The Corporation of the
Town of Milton
Committee of Adjustment and Consent

Thursday, June 26, 2025, 6:00 p.m.
Council Chambers - In Person

The Corporation of the
Town of Milton
Committee of Adjustment Minutes

Attachments
Figure 1 - Site Plan

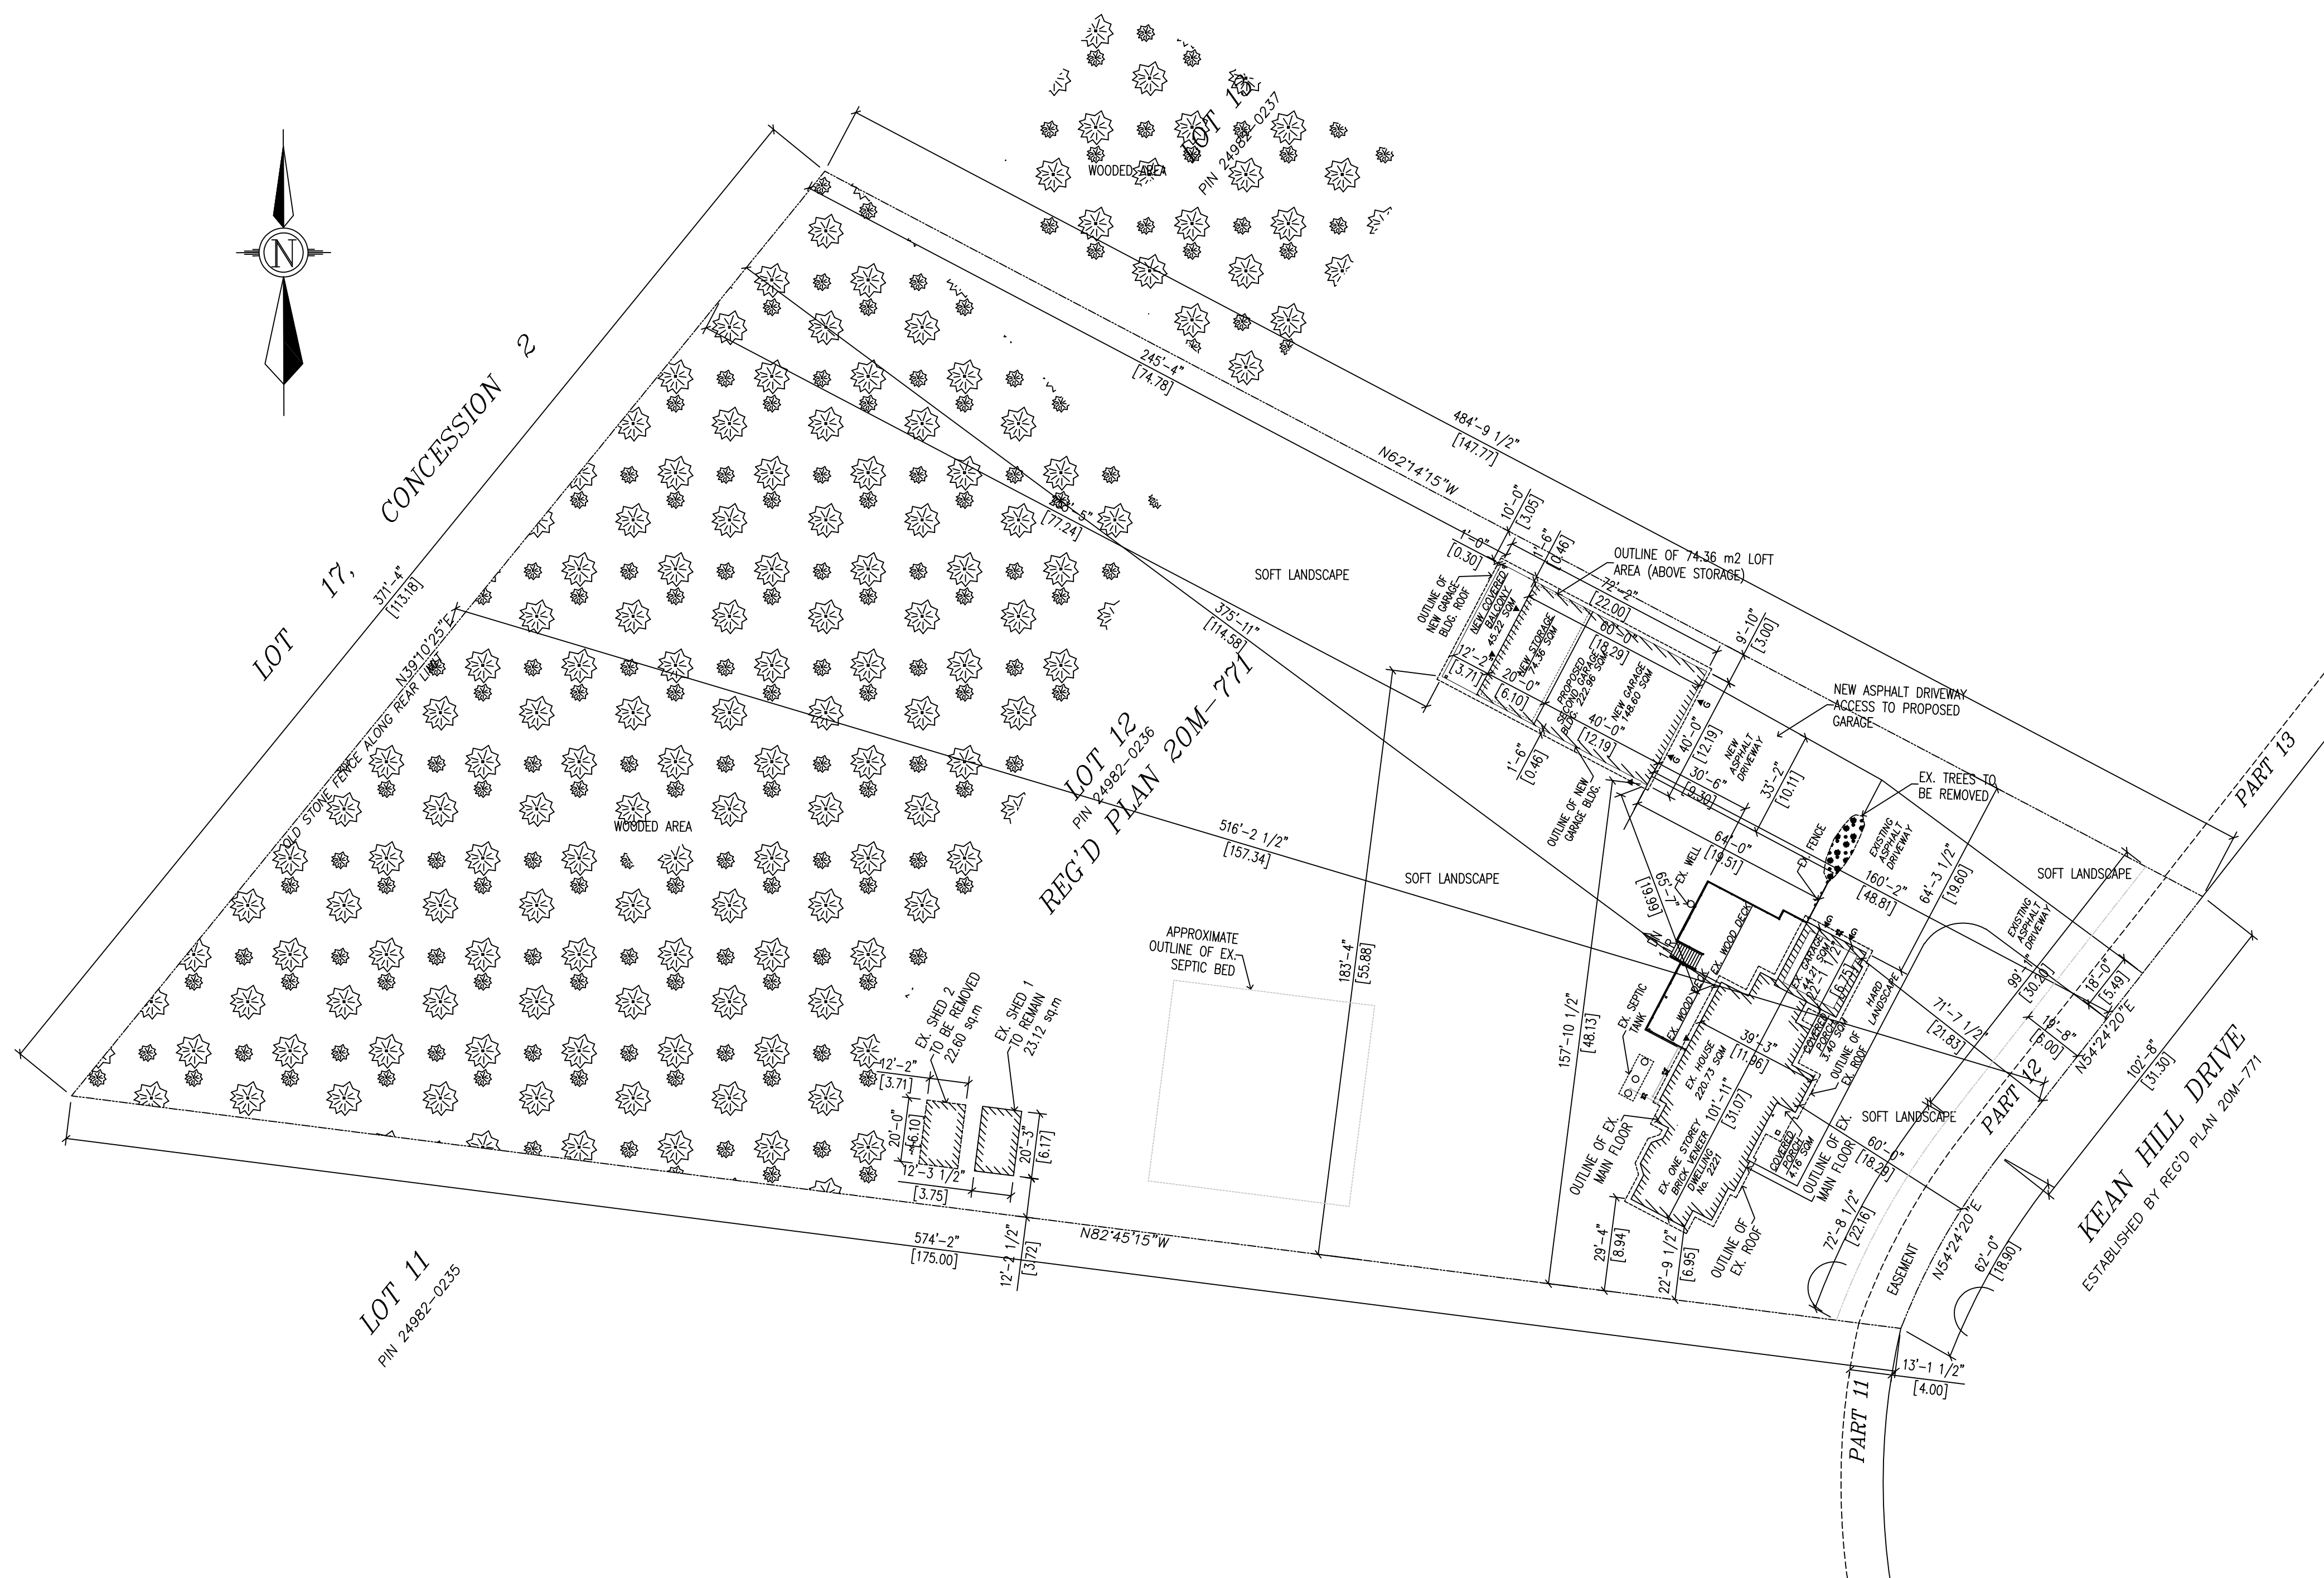
The applicant is requesting permission to allow for a driveway width of 10.11 metres, a difference of + 2.11 metres, to facilitate the proposed development. The proposed driveway will be an extension of the existing driveway and will provide access to the proposed detached garage. Planning staff are of the opinion that this location is appropriate and in close proximity to the existing dwelling on the property which is ideal.

The applicant is requesting permission to allow for a garage height of 6.7 metres, a difference of + 2.4 metres, to facilitate the proposed development. Further, the applicant is also requesting permission to allow for a garage door height of 3.7 metres, + 1.3 metres, to facilitate the proposed development. The applicant did provide details which confirmed the height increase is related to the installation of a car lift within the detached garage. Planning staff do not have concerns with the proposed increase in height and garage door height as the property does include a hedgerow along the interior side yard which will assist with shielding from the neighbouring property. Further, the proposed detached garage is setback sufficiently from the interior side yard.

The applicant is requesting permission to allow for two garages to be on the property, existing attached and proposed, to facilitate the proposed development. Planning staff do not have concerns with the proposed detached garage as the applicant has provided reasonable explanation for the specific personal needs for additional storage on the property. Further, the proposed detached garage is not considered overdevelopment as the subject property is approximately 3 acres in size as well as our maximum lot coverage provision has not been met.

1. That the development shall be constructed in accordance with the site plan prepared by Care Engineering & Design Services Inc. and stamped by Town Zoning on May 15, 2025.
2. That the detached garage be used for storage of personal vehicles and items only and will not be used for human habitation or business purposes.
3. That the applicant proceeds with tree planting near the interior side yard and location of the proposed detached garage.
4. That a Building Permit be obtained within two (2) years from the date of the decision; and
5. That the approval be subject to an expiry of two (2) years from the date of decision if the conditions are not met, if the proposed development does not proceed and/or a building permit is not secured.
